Limited Visual Dam Safety Inspection Summary Report

MA-079

Reservoir 52

Limited Visual Dam Safety Inspection Conducted on: 04 April 2006

079 downstream slope cut

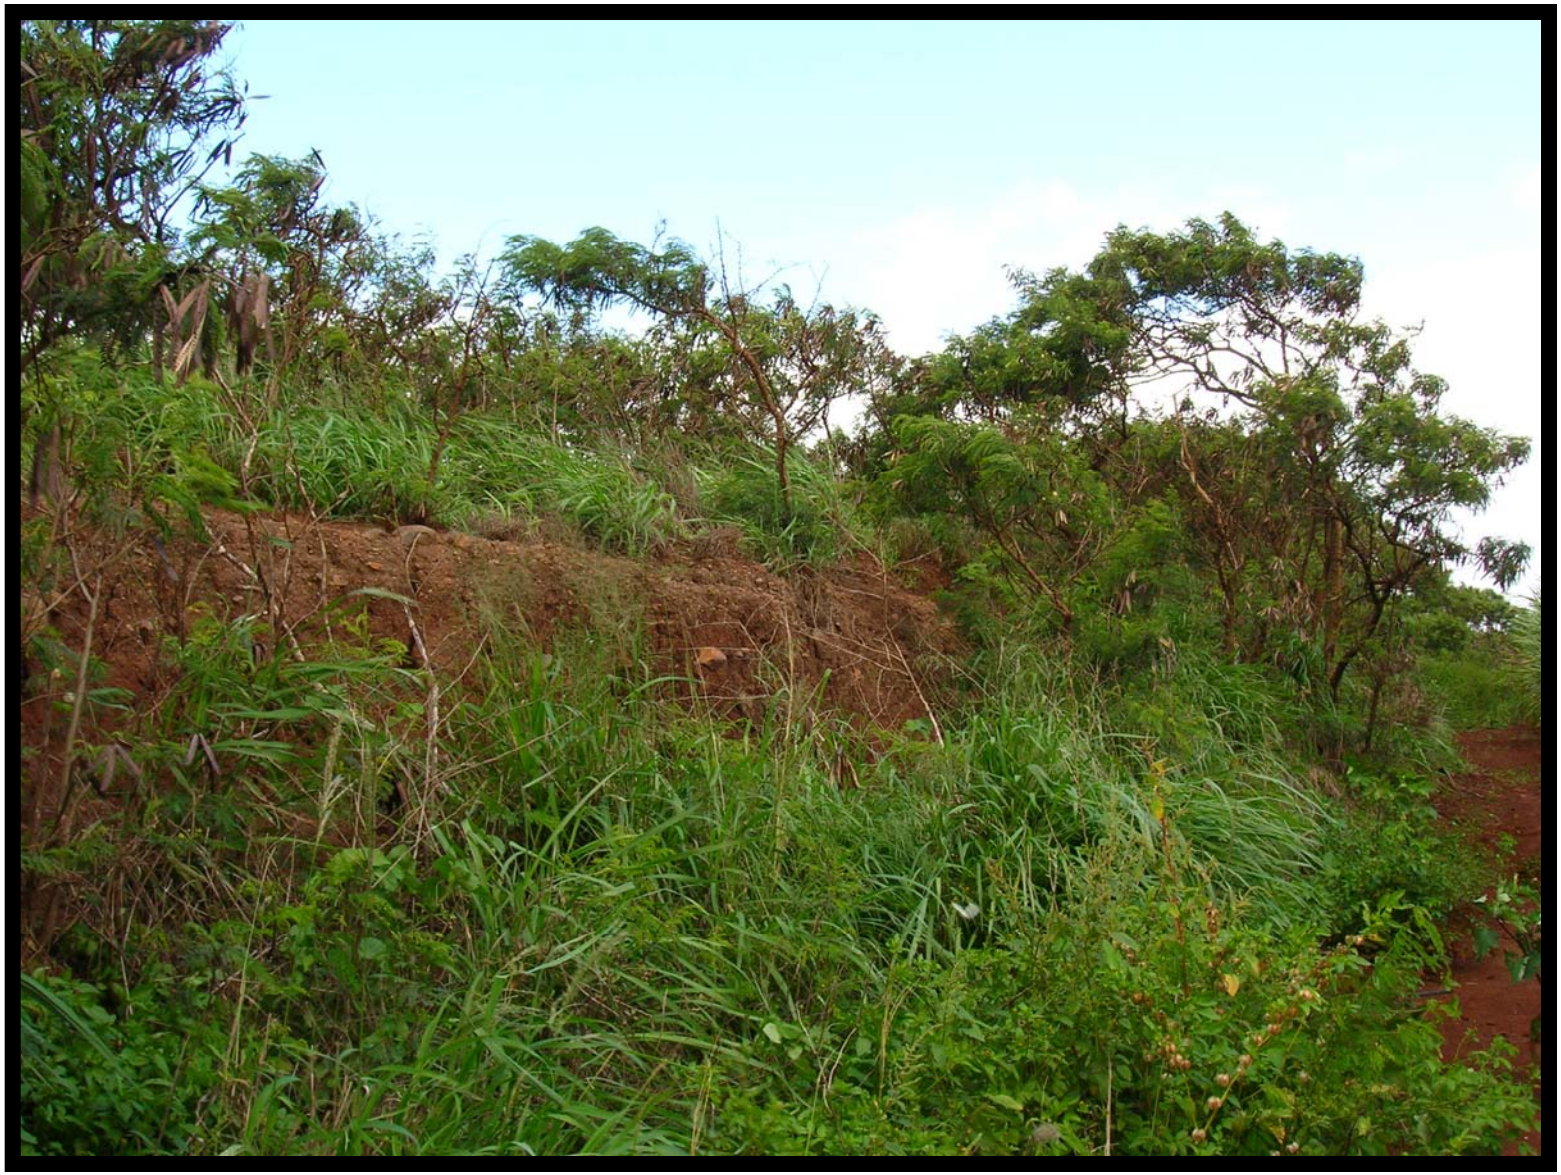
a. The downstream slope appeared to be in fair to poor condition and requires corrective action.
b. The down stream slope was not visible due to high grass and bush vegetation. Clear high vegetation and maintain low to enable easy visual inspection.
c. Tree(s) were observed on the downstream slope. Trees have been identified as the probably cause of piping failures, and can possibly cause sever damage to the embankment if they are uprooted during a high winds. Corrective action is required to remove the tree hazards from the dam. Acceptable remedies include

d. The slope was very steep, around a 1 to 1 slope; further study is required to verify slope stability.
e. Vertical scarps and rodent holes should be addressed

079 downstream toe 2

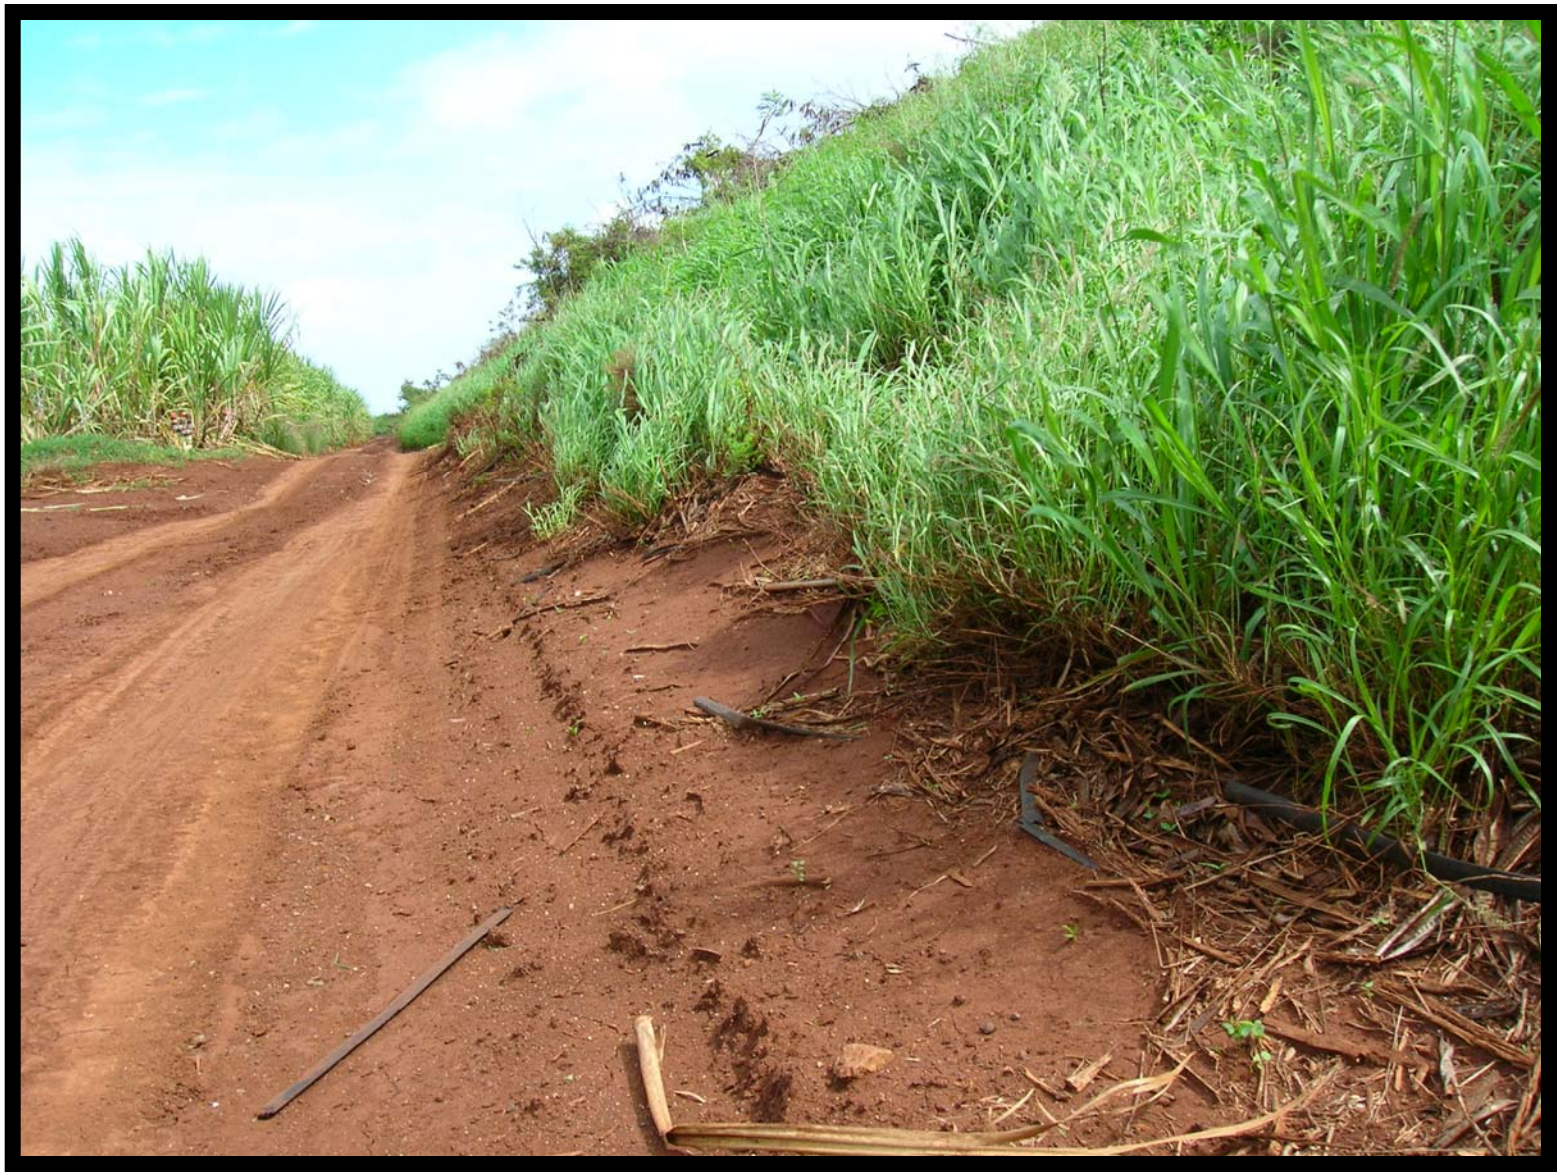
a. The abutments/toe were not inspected.
b. The abutments/toe appeared to be in fair to poor condition and requires corrective action.
c. The abutment/toe area was not visible due to high grass and bush vegetation. Clear high vegetation and maintain low to enable easy visual inspection.
d. Tree(s) were observed along the abutment/toe. Trees have been identified as the probably cause of piping failures, and can possibly cause sever damage to the embankment if they are uprooted during a high winds. Corrective action is required to remove the tree hazards from the dam. Acceptable remedies include removal of the tree and its root structure down to a 2" diameter and reconstructing the damaged embankment section. All repair work shall be accomplished as per the requirements of licensed geotechnical or structural engineer. Routinely monitor the damaged area for signs of settlement and seepage.

079 inlet 2

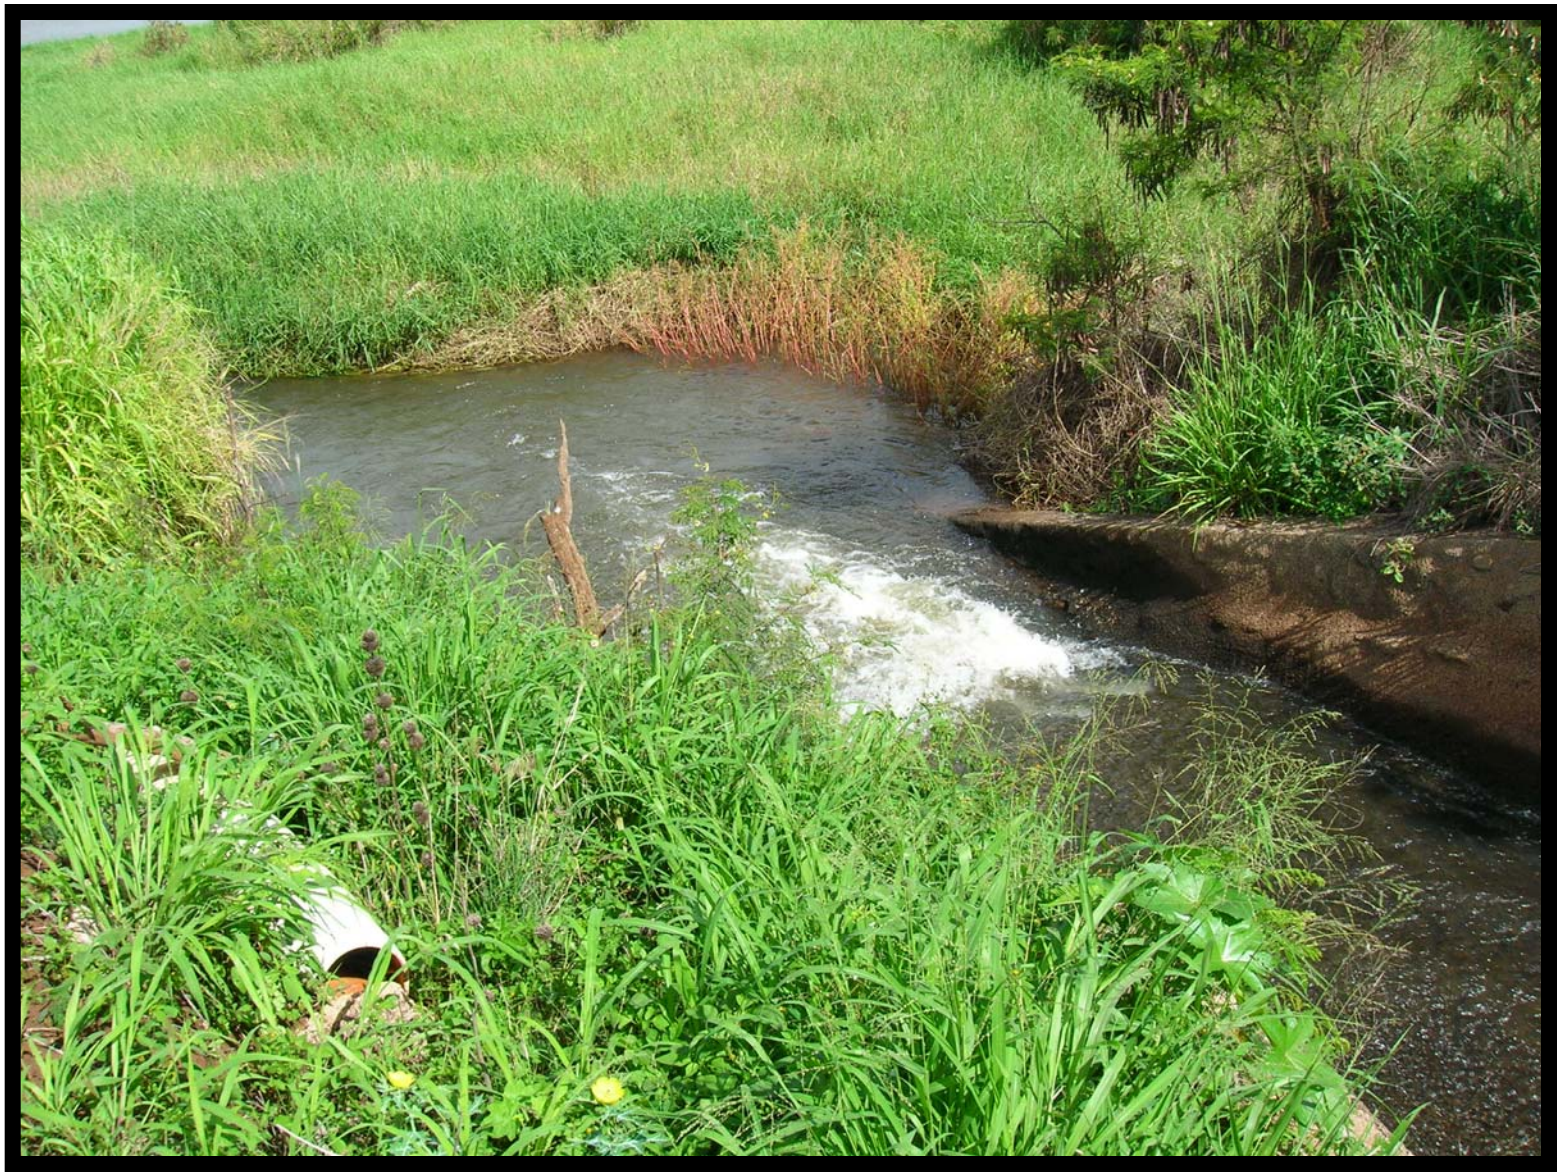
a. The intake works were not tested.
b. The intake works appeared to be in satisfactory condition, no corrective actions are required at this time.

079 outlet works

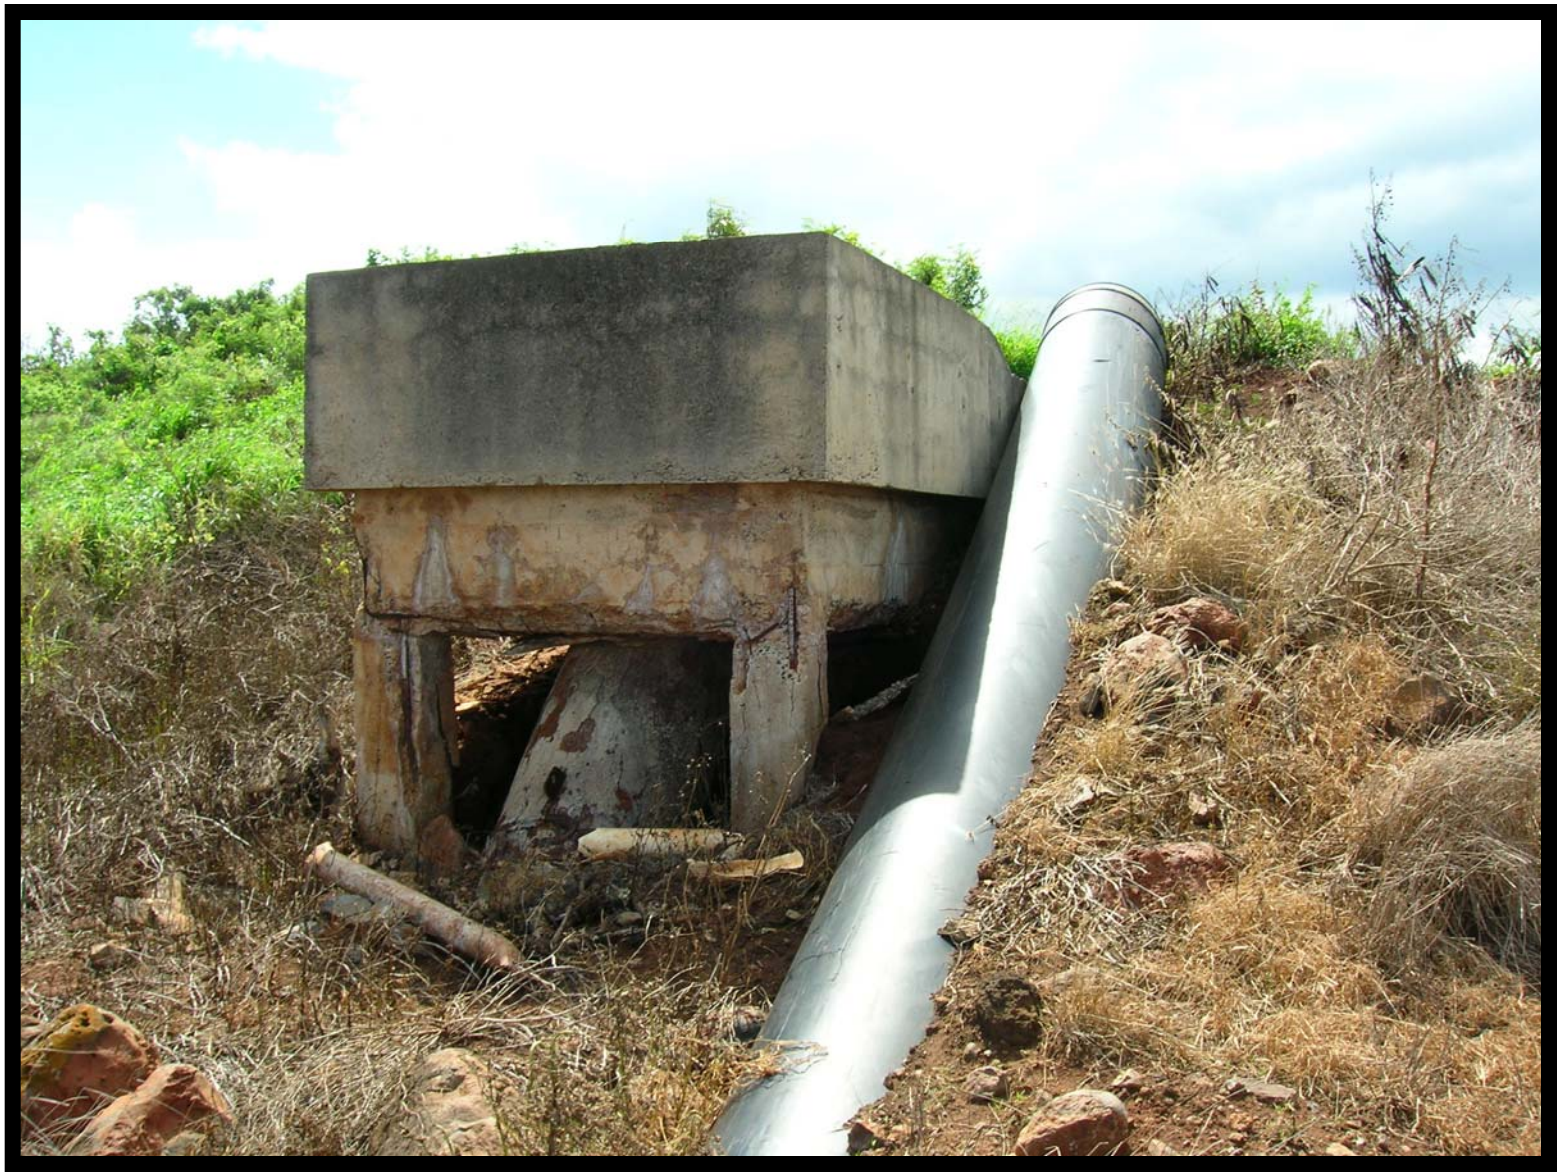
The outlet works appeared to be two 36" steel pipes.
Not inspected in detail, not tested.
The heavy vegetation should be removed and maintained low to enable easy visual inspection.
The outlet works was controlled via a gate valve on the upstream side of the dam.
Seepage was not visible flowing near the exit of the outlet works from the dam.

b. The outlet works appeared to be in satisfactory condition, no corrective actions are required at this time.
